Finch Hollow Watershed Project, Site 1. Inventory Number NY-697
Susquehanna River Basin. Broome County,
New York. Phase 1 Inspection Report,

SUSQUEHANNA RIVER BASIN
FINCH HOLLOW WATERSHED PROJECT - SITE I
NY 697
PHASE I INSPECTION REPORT

Name of Dam: Finch Hollow Watershed Project - Site 1
I.D. No. NY 697

ASSESSMENT

Right Side of Principal Spillway Riser
Photo #3

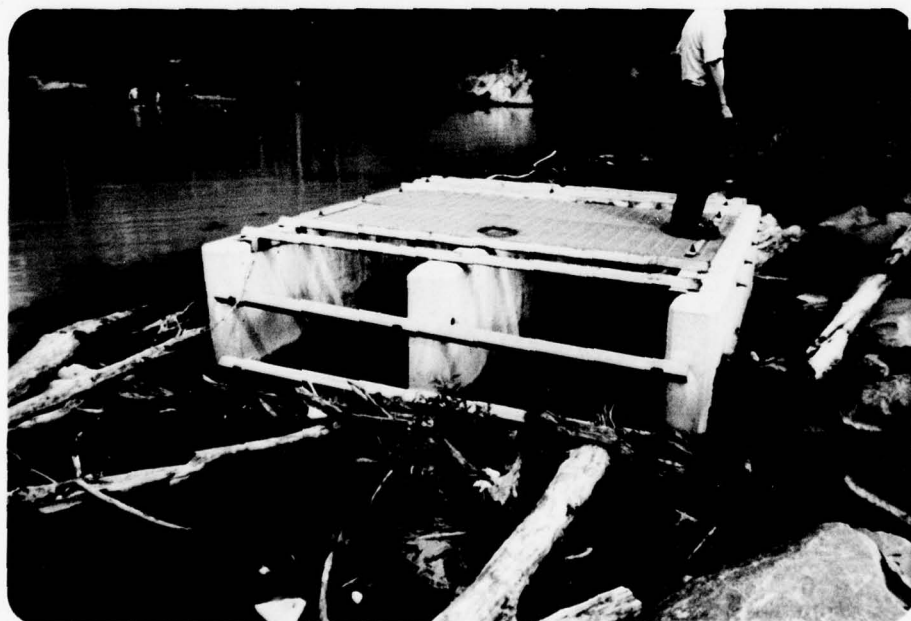
1. The riser top grating is loose and the bolting units require repair. (See photo #5);
2. Considerable debris is surrounding the intake of the principal spillway. This debris should be removed with periodic removals conducted in the future. (See photos #3 & 4).

1. Remove the tree growth at the entrance and exit of the auxiliary spillway channel to permit the unimpeded flow of discharge water;
2. Repair the bolting units of the principal spillway riser grating;
3. Remove the debris surrounding the principal spillway riser intake. Provide a program of periodic inspection and maintenance of the dam and appurtenances, including operation and lubrication of the slide gate mechanism. Document this information for future reference;
